SPECIAL COUNCIL COMMITTEE MEETING

1. Discuss Location of Senior Citizens Center

Stephenville Senior Citizens Center

Certified Arborist Opinion

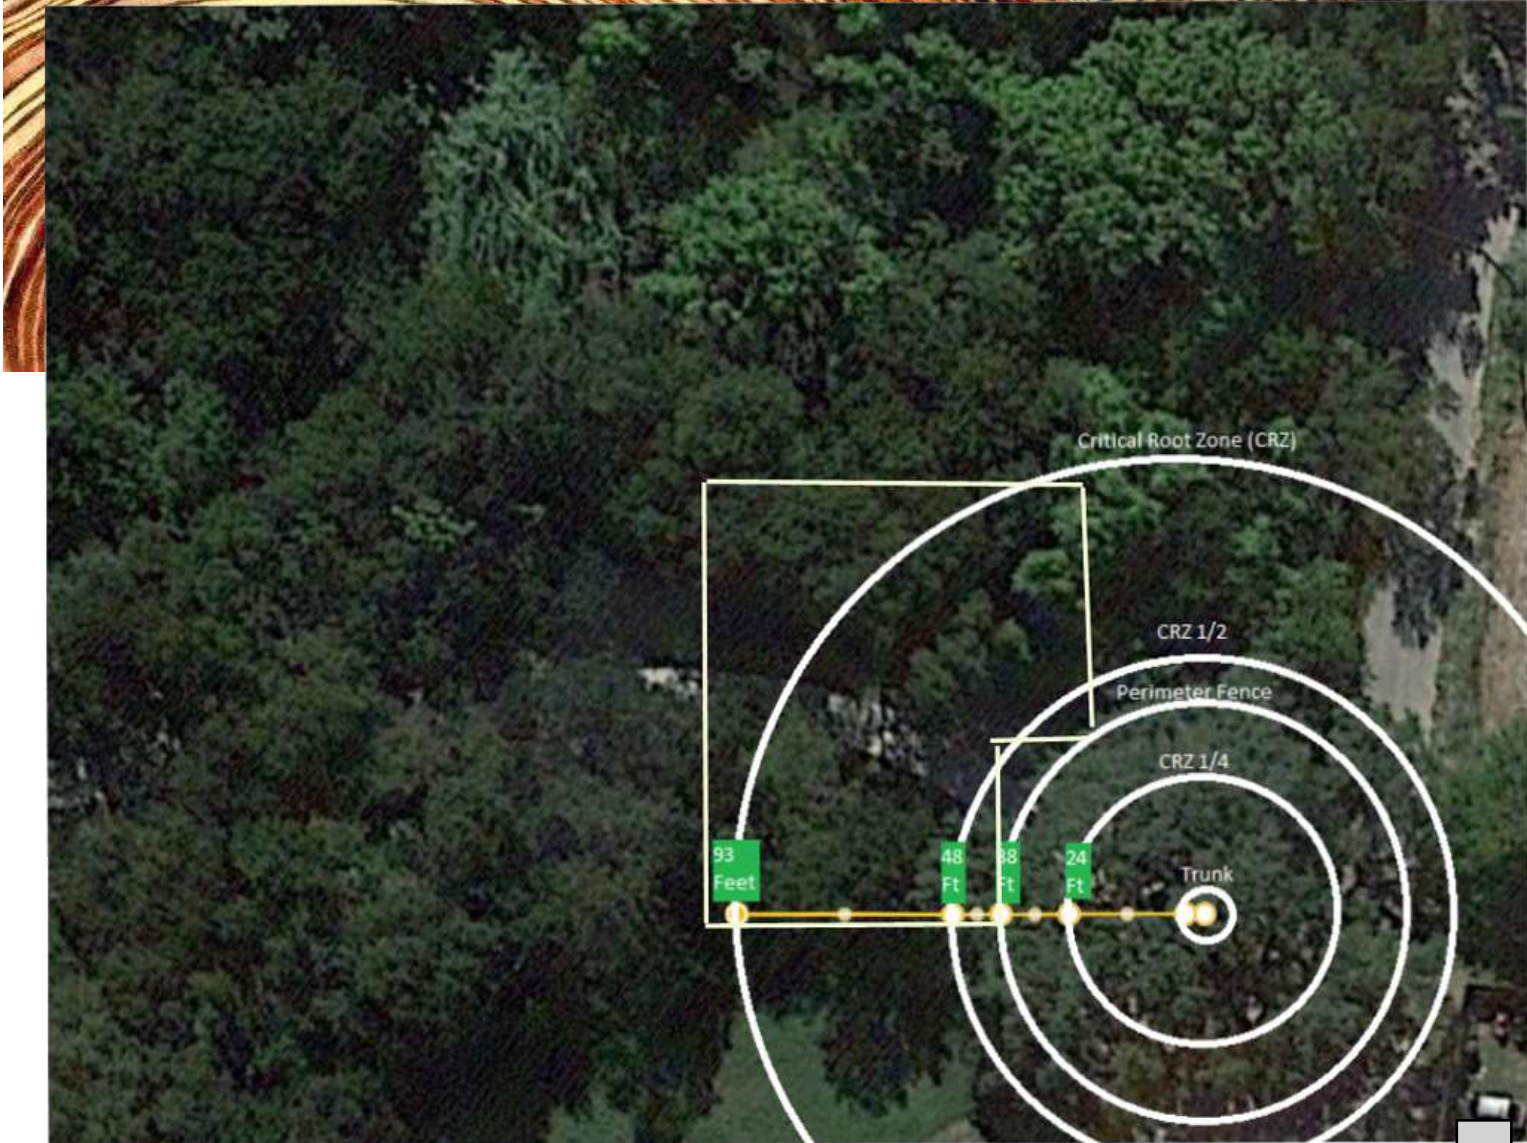
There is evidence of intention to protect the tree from the construction process and the actual building. The protection is inadequate for several reasons.

The existing orange mesh barrier is inadequate as protection. It is physically flimsy and being ignored by workers in several ways. The area inside of that barrier has **already been violated** with equipment traffic and fill soil was placed inside the barrier.

The barrier does not encompass a large enough area. **Much of the existing barrier is placed inside the minimum distances** from the tree.

The current barrier has erratic placement at distances from 35 to 54' from the tree.

There is no interior or Quarter Critical Root Zone marked or protected.

ANSI Standards would require noting and considering the complete Tree Protection Zone area of a minimum of 1 foot per diameter inch. For this tree a 93' radius - at minimum.

The **Quarter Critical Root Zone (CRZ) should be 24' at a minimum.** I would recommend increasing it because part of the trees root zone on the opposite side is restricted by a street. The streets effect probably increases reliance on the remaining root zone area. No changes or traffic should be allowed on this area.

The **Half Critical Root Zone (CRZ) should be 47' at minimum.** A maximum of 4" of additional coverage or 4" removal of soil on 50% of this area might be tolerated by the tree.

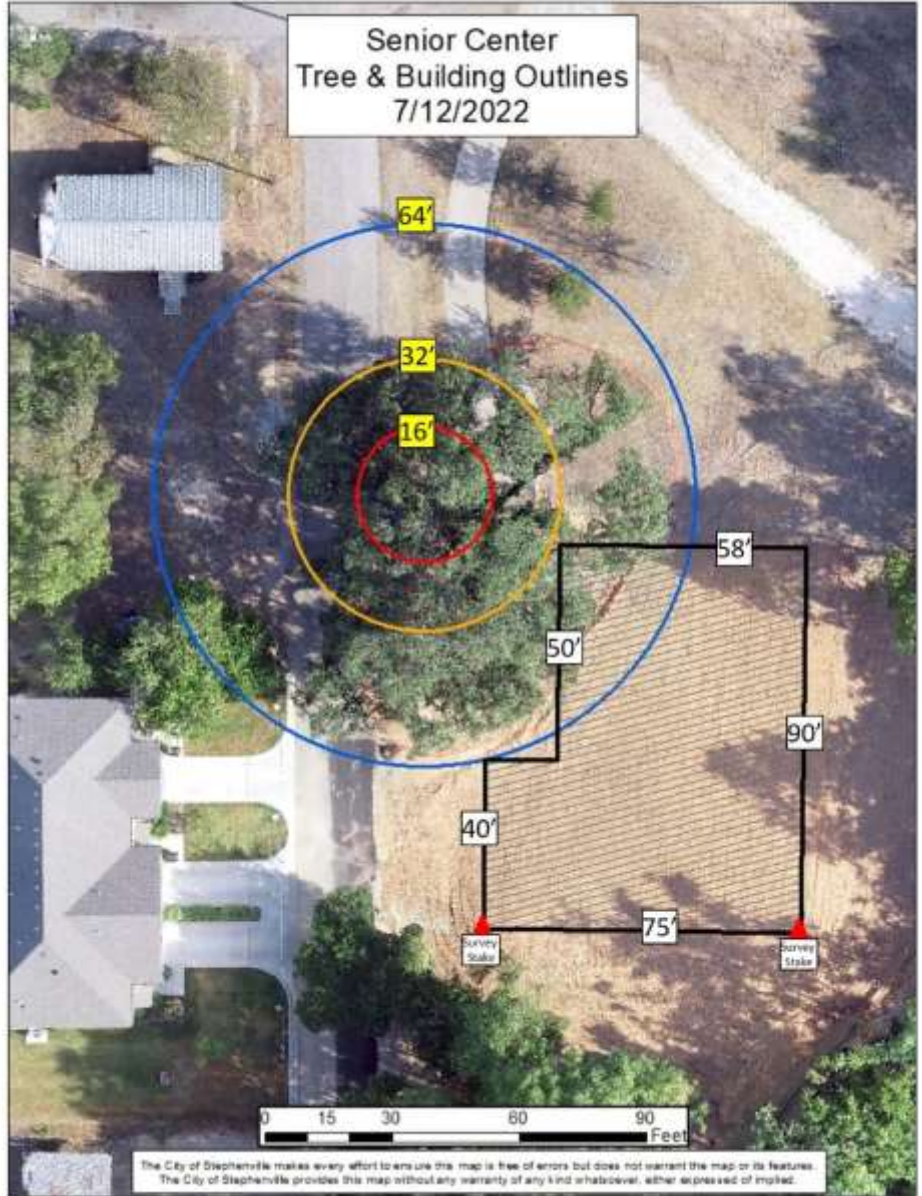
Proper measurement of the tree at 4 - 4 ½ ft above ground according to City of Austin building code and TxDOT tree preservation guidelines and Texas Forest Service practices.

Circumference = 201 in.

Diameter = 64 in.

Critical Root Zone = 64 ft.

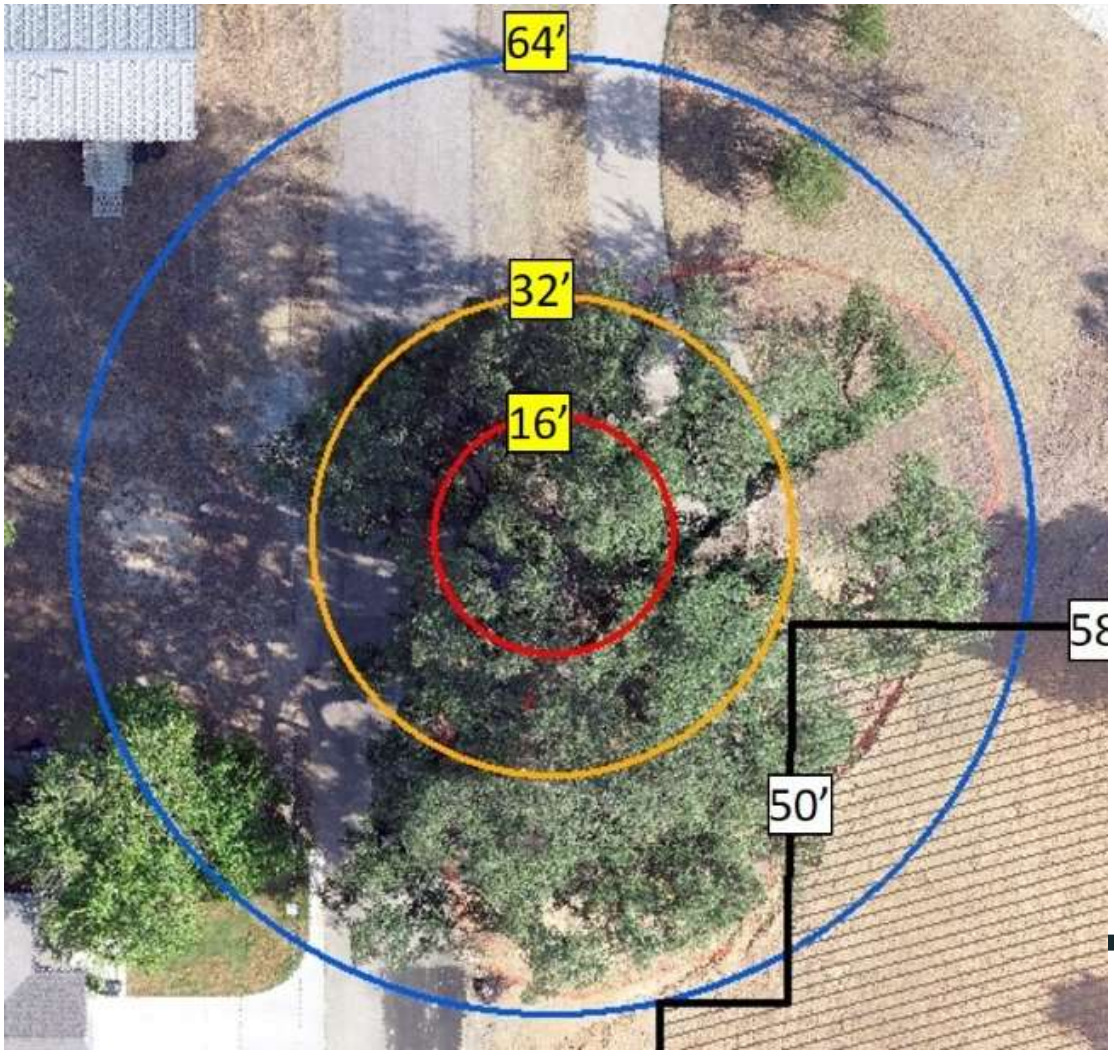
Building does not impact the 1/4 or 1/2 CRZs

Tree Preservation Criteria Best Practices from City of Austin Building Code

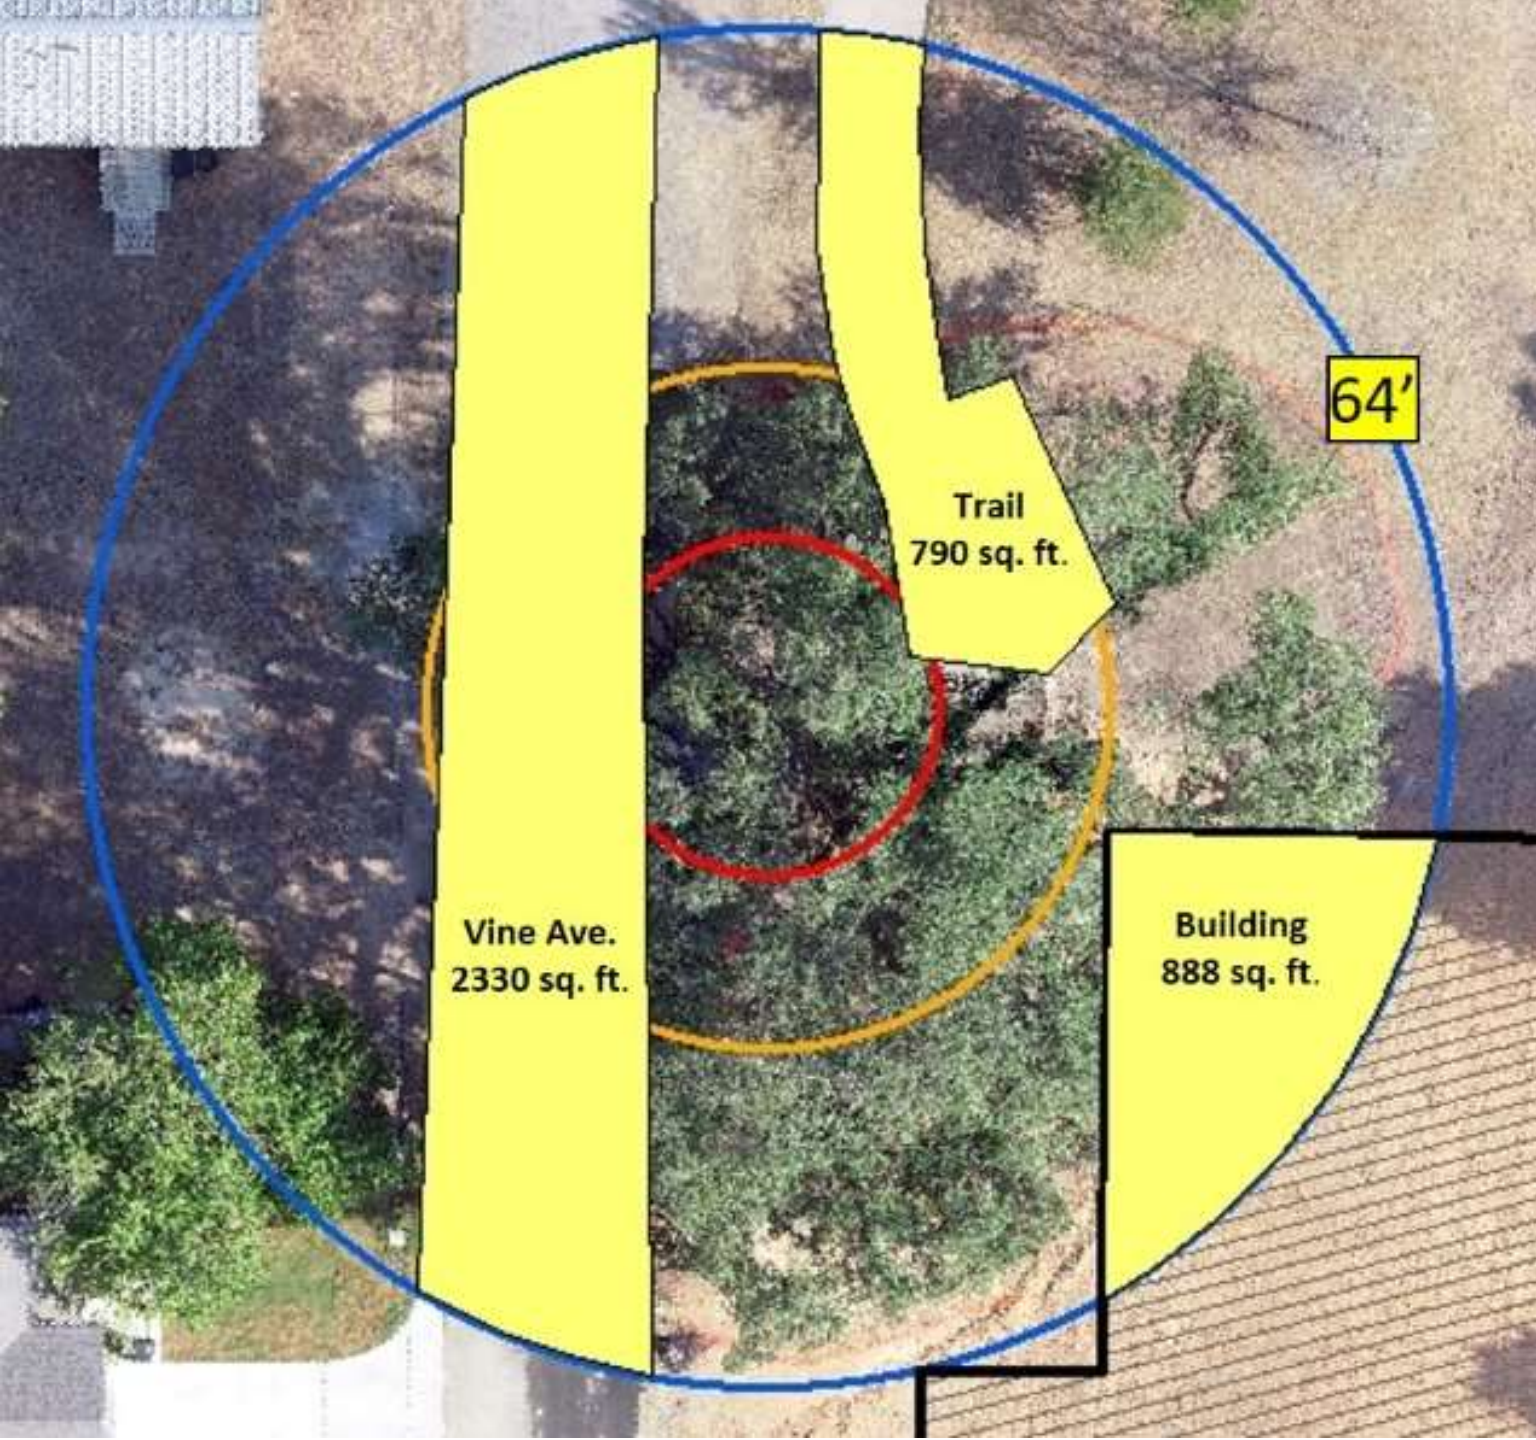
**Total impact on CRZ,
including existing
roadway and
sidewalks = 31%**

Building placement meets exception guidelines to City of Austin Building Code

- Building impacts no part of $\frac{1}{4}$ CRZ
- Building impacts no part of $\frac{1}{2}$ CRZ
- Total impact less than 50% of total CRZ

- Add 4" mulch within 16ft $\frac{1}{4}$ CRZ
- No more than 4" cut/fill within 32 ft $\frac{1}{2}$ CRZ
- Carefully remove any unnecessary fill dirt within the $\frac{1}{2}$ CRZ
- Construct 4ft rigid fence to ensure protection of 32ft $\frac{1}{2}$ CRZ during construction process. Consider re-route of existing trailhead sidewalk to locate it outside $\frac{1}{2}$ CRZ
- Ensure street side parking on west side of building remains outside CRZ
- Maintain natural grade wherever possible and evaluate drainage to ensure pooling does not occur within the CRZ
- Hire a certified arborist to manage and supervise any canopy trimming necessary for construction of the building.
